DEVELOPMENT ASSESSMENT REPORT	
<b>Application No.</b>	D/2019/477
<b>Address</b>	14 Paul Street BALMAIN EAST NSW 2041
<b>Proposal</b>	Boundary adjustment, rear extension to existing house, new two-storey dwelling with basement and pool.
<b>Date of Lodgement</b>	22 November 2019
<b>Applicant</b>	Coso Architecture David Tow
<b>Owner</b>	Mr Philip J Harding
<b>Number of Submissions</b>	Initial: 4 After Renotification: 1
<b>Value of works</b>	\$550,880.00
<b>Reason for determination at Planning Panel</b>	Clause 4.6 variation exceeds 10%
<b>Main Issues</b>	View Loss, Heritage Streetscape
<b>Recommendation</b>	Approved with Conditions
<b>Attachment A</b>	Recommended conditions of consent
<b>Attachment B</b>	Plans of proposed development
<b>Attachment C</b>	Clause 4.6 Exception to Development Standards
<b>Attachment D</b>	Statement of Heritage Significance

This report is an assessment of the application submitted to Council for the re-subdivision of the existing two lots comprising the site so as to form two similar rectangular lots; alterations and additions to the existing dwelling on one lot, and to erect a new two-storey dwelling with basement and pool on the other lot at 14 Paul Stre

DEVELOPMENT APPLICATION D/2019/477 AMENDED DOCUMENTATION  
 14 PAUL STREET, BALMAIN EAST 2041

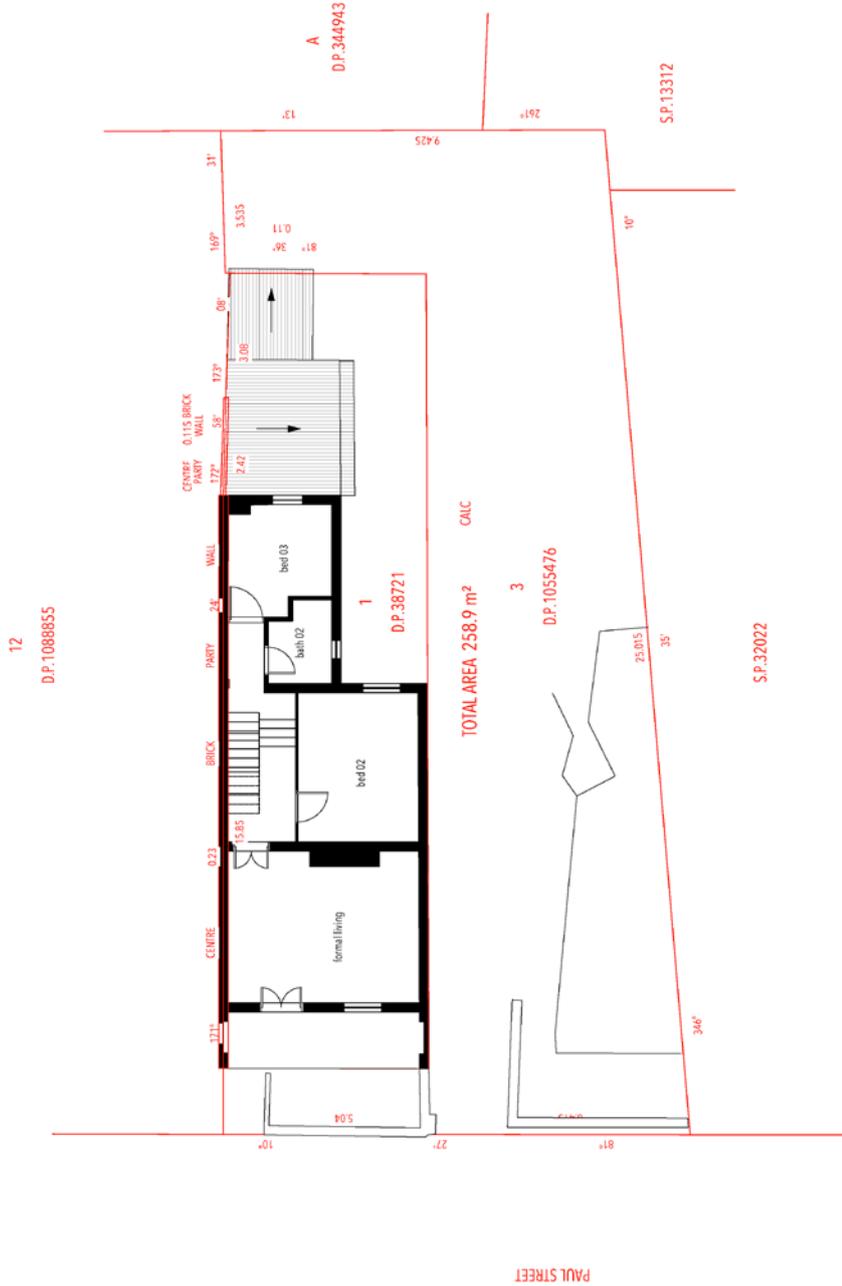
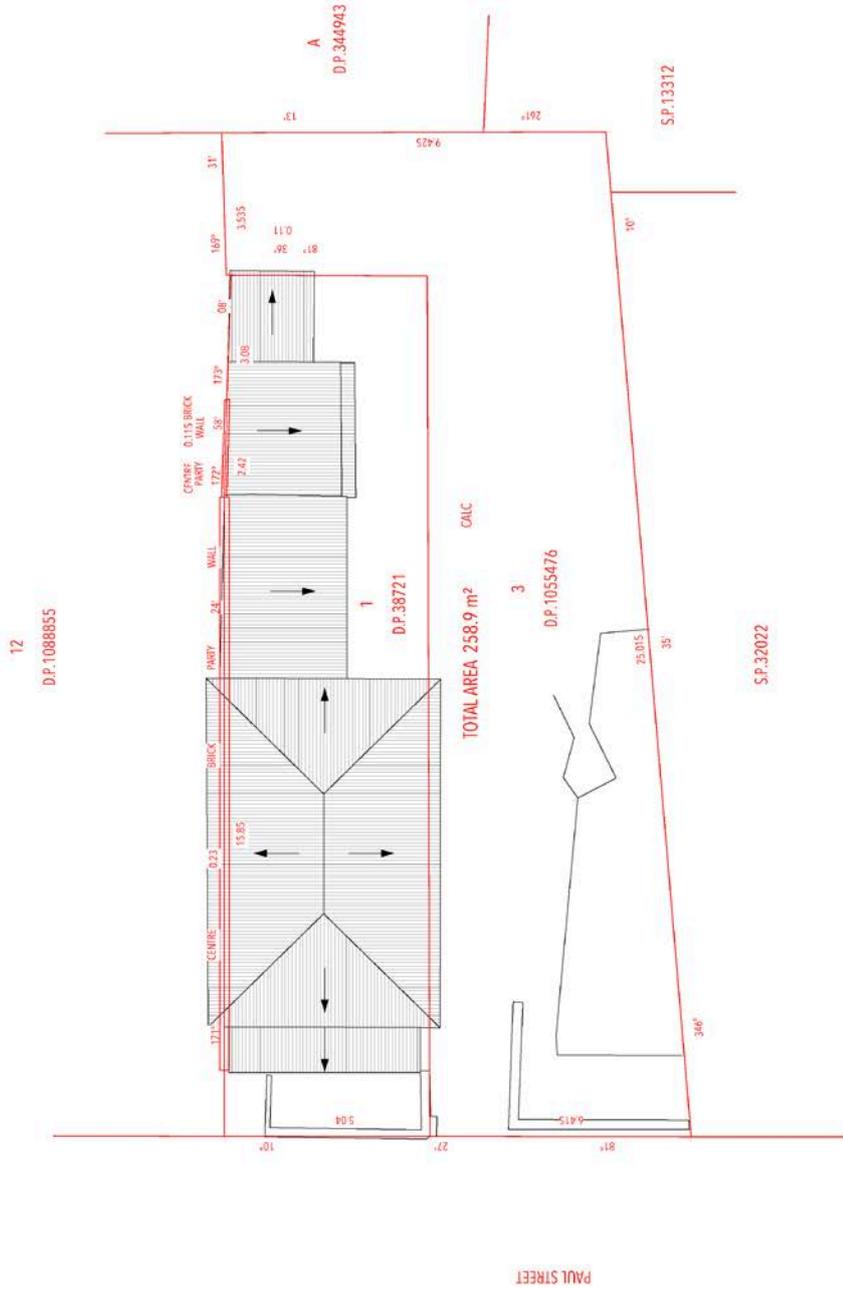
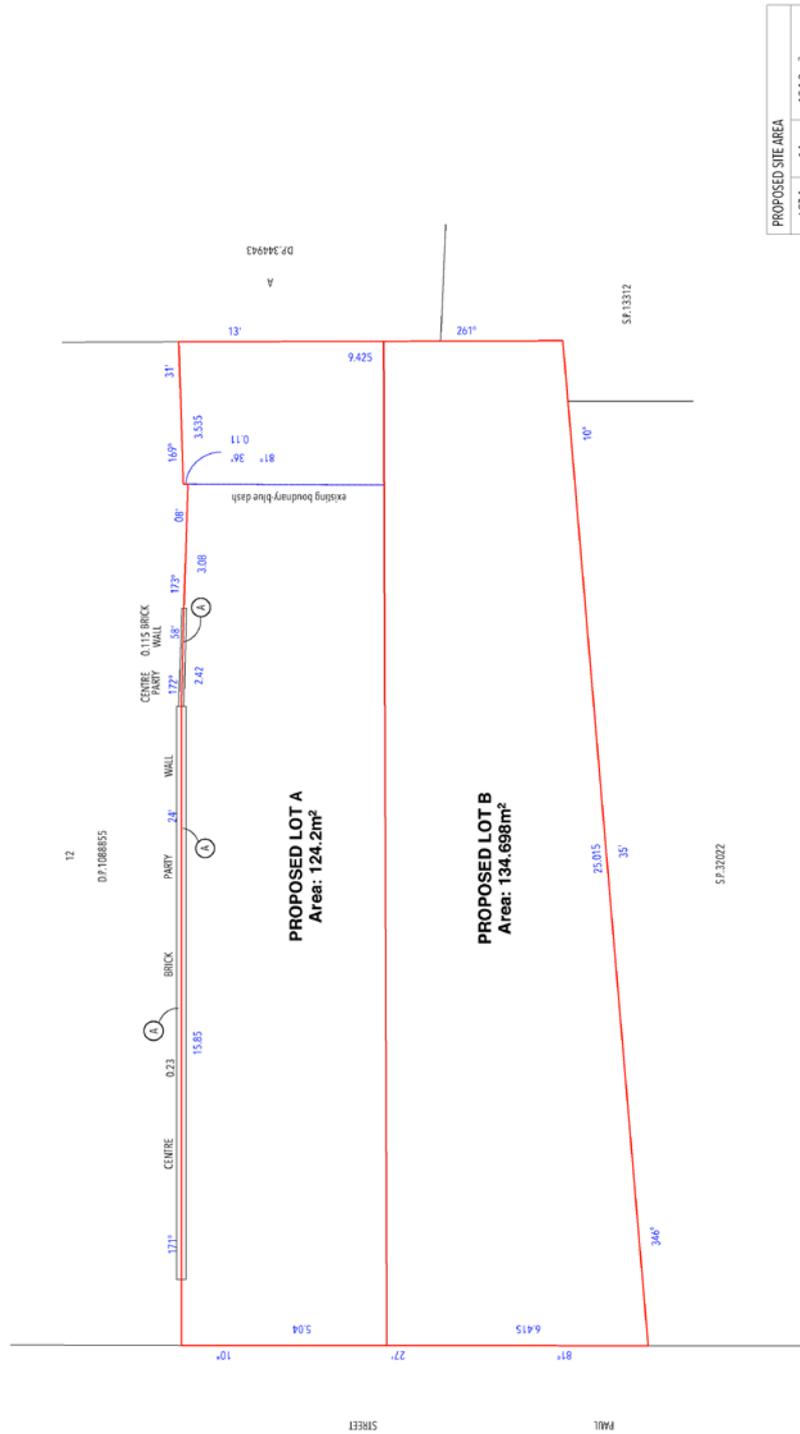
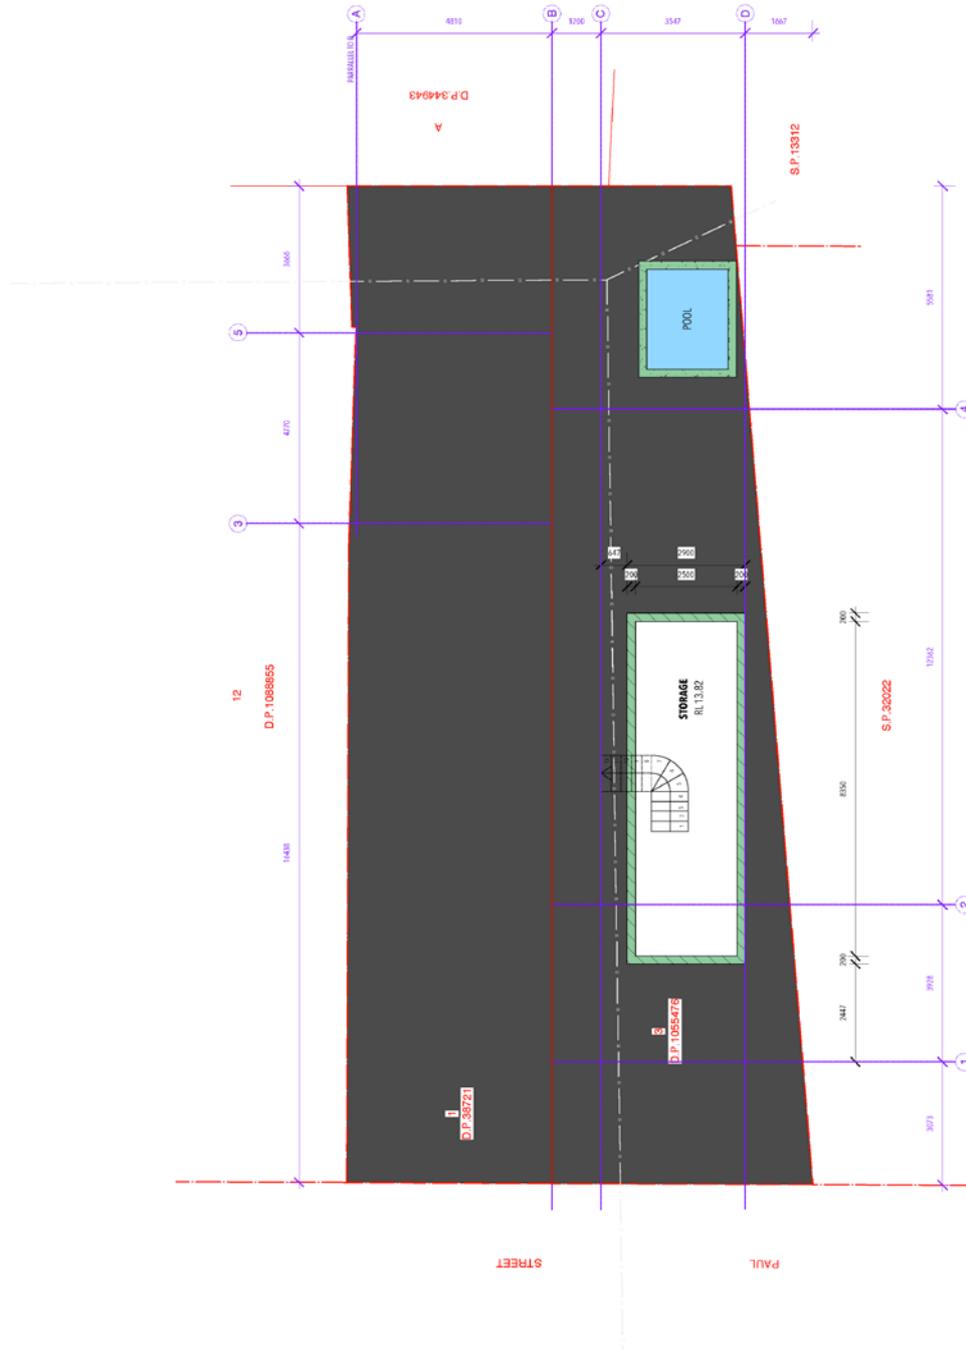
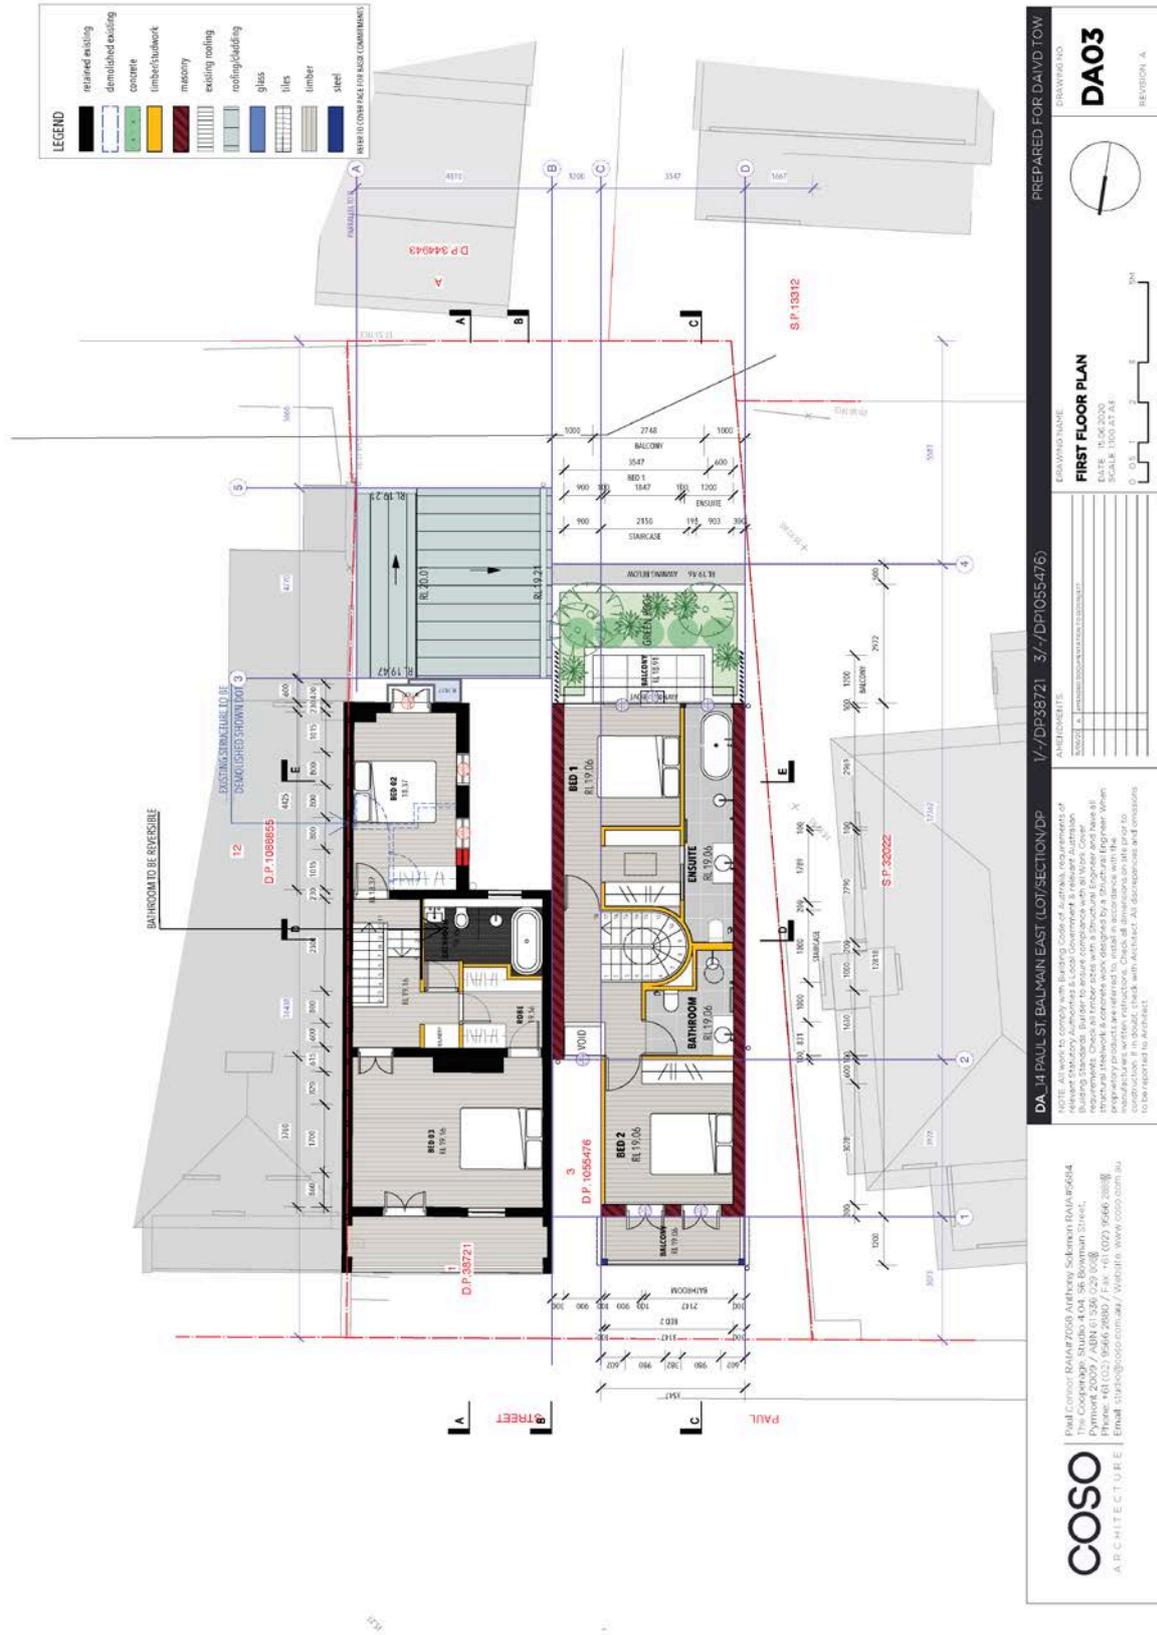
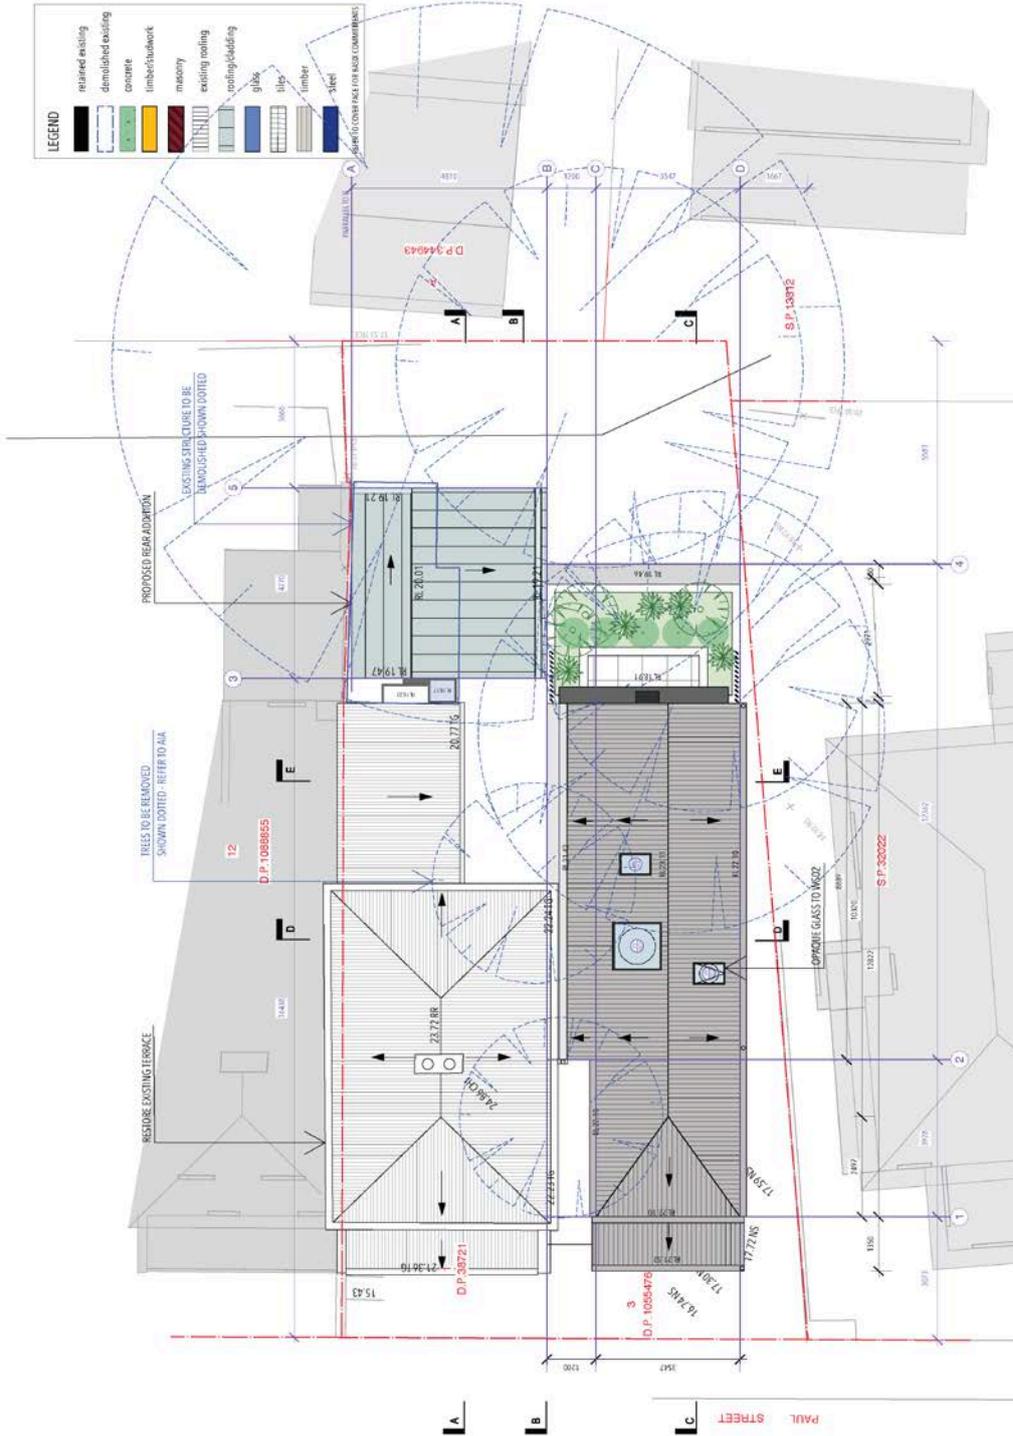
The amended plans show the orientation of the proposed dwelling has been realigned so it is parallel with the adjoining terrace. This is an acceptable outcome as the dwelling will complement the rhythm of the row of heritage listed terraces it will adjoin. It is also positive as it will result in the retention of the existing rockface in the garden, which is consistent with the objectives O1 and O2 and controls C1a and C1b of Part C1.19 of the LDCP.

The amended plans are considered acceptable on heritage design grounds subject to amendments in accordance with the following design change conditions which should be included in any consent.

- i. Replace the “Burlesque” mid-toned flush jointed brickwork proposed in the front elevation with “Limewash” from the San Selmo Reclaimed Austral bricks range. Alternatively, the front façade can be rendered and painted in Dulux “Snowy Mountains” or “Stowe White”, or similar.
- ii. Replace black for the timber French doors in the front elevation with Pale Green from the Dulux Traditional colour range, or similar.

- iii. The stormwater drainage design on drawing No.19.552/SW1 prepared by E2 CIVIL & STRUCTURAL DESIGN is not accepted as the Stormwater Drainage Concept Plan. In this regard, the proposed pump-out system for the basement is not satisfactory. The basement must be fully tanked.

An exposed rock shelf exists on the western boundary of the site. The amended plans relocate the new dwelling away from the western side boundary and retain a greater portion of the exposed rock shelf. A condition is recommended to be placed on any consent that the rock shelf is to be protected and retained with excavation and works not extending beyond the immediate walls of the new dwelling on the western lot, Lot B (14A Paul Street).

Specific details of proposed fencing have not been provided. However, the submitted plans indicate a vertical palisade fence to the front boundary of the new dwelling at Lot B (14A Paul Street). A condition is recommended to be imposed on the consent limiting any front fence to a vertical palisade or picket fence having a maximum height no greater than 1.2m at any point, so as to maintain consistency with the streetscape

However, the amended plans have aligned the front façade wall and verandah with that of the existing dwelling at 14 Paul Street. This has resulted in the expected and assessed view loss.

Although the breach of site coverage is minor, and the proposed lot sizes are similar to those existing in the area, a relatively minor modification to the submitted design could ameliorate the assessed Harbour Bridge view loss impact to 1/16 Paul Street.

Such a setback would remove the majority of the view loss impact to 1/16 Paul Street caused by the new dwelling. In this regard, draft amended drawings were submitted on 24/8/2020 in response to a viewing of the height poles. These plans required further renotification and therefore were not accepted.

- d. Charged or pump-out stormwater drainage systems are not permitted including for roof drainage; *The stormwater drainage design on drawing No.19.552/SW1 prepared by E2 CIVIL & STRUCTURAL DESGN is not accepted as Stormwater Drainage Concept Plan. The proposed pump out system for the basement is not permitted, the basement must be fully tanked.*
